Access Compliance Report

Public Rights-of-Way

(Curb Ramps)

Intersection ID: N/A	Main Street: E_PROVIDENCE_RD	Cross Street: N/A	Location: S
ADA ID: 1223E87615D3	Ramp Type: PerpDiag	Initial Pass/Fail: Fail	Overall Compliance: No
Severity Score: 22.5			
Codes/Mitigation Info/Possible Solution		Field Measurements/Component Compliance

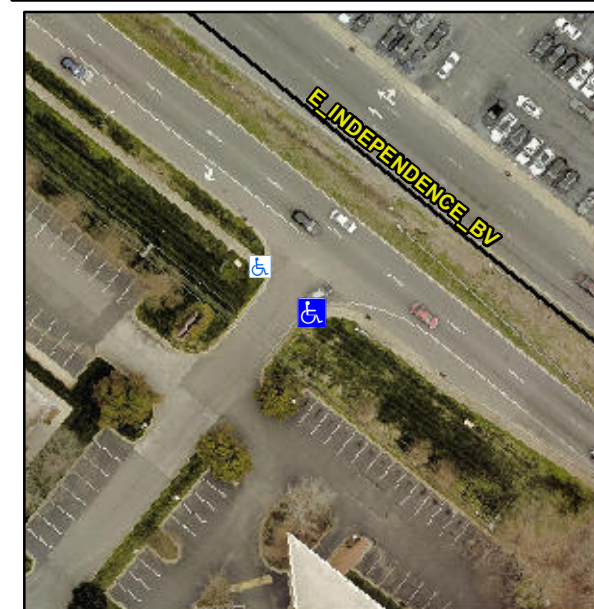
R304.5.1, R304.2.2

Compliance	Description	Data	Compliance	Description	Data
N/A	Ramp Length (in)	60.0	No	Ramp Slope (%)	11.4
No	Ramp Width (in)	37.0	Yes	Ramp XSlope (%)	3.3
N/A	Flare Type LT	N/A	N/A	Flare Type RT	N/A
N/A	Flare Slope LT (%)	N/A	N/A	Flare Slope RT (%)	N/A
N/A	Flare Traversable LT?	N/A	N/A	Flare Traversable RT?	N/A
N/A	Landing Length (in)	N/A	N/A	DWS Provided?	N/A
N/A	Landing Width (in)	N/A	N/A	DWS Contrast?	N/A
N/A	Landing Slope (%)	N/A	N/A	DWS Length (in)	N/A
N/A	Landing X Slope (%)	N/A	N/A	DWS Full Width?	N/A
N/A	Landing Curb? (Y/N)	N/A	N/A	DWS Offset (in)	N/A
N/A	Shared Landing?	N/A			
N/A	Gutter Ponding?	N/A	N/A	Gutter Slope (%)	N/A
N/A	Gutter Lip Ht (in)	N/A	N/A	Gutter X Slope (%)	N/A
N/A	Painted X Walk1?	No	N/A	Painted X Walk2?	No
	X Walk 1 Direction	To NE		X Walk 2 Direction	To NW
N/A	X Walk 1 Width (in)	N/A	N/A	X Walk 2 Width (in)	N/A
	X Walk 1 Slope (%)	6.5		X Walk 2 Slope (%)	4.9
	X Walk 1 X Slope (%)	0.8		X Walk 2 X Slope (%)	0.2

N/A	Ramp inside XWalk1?	N/A	N/A	Ramp inside XWalk2?	N/A
	Road Slope (%)	5.5	N/A	Clear Space?	N/A
	Road X Slope (%)	5.7	N/A	Clear Space to XWalk (in)	N/A
N/A	Any Obstructions?	N/A	N/A	Storm Grate/Utility Hazard?	N/A
	Obstruction Type			Storm Grate/Utility Type	
		N/A			N/A
			Yes	Surface Condition? (G/P)	Good

Remove & Replace Curb Ramp With Two New Directional Ramps or Equivalent.
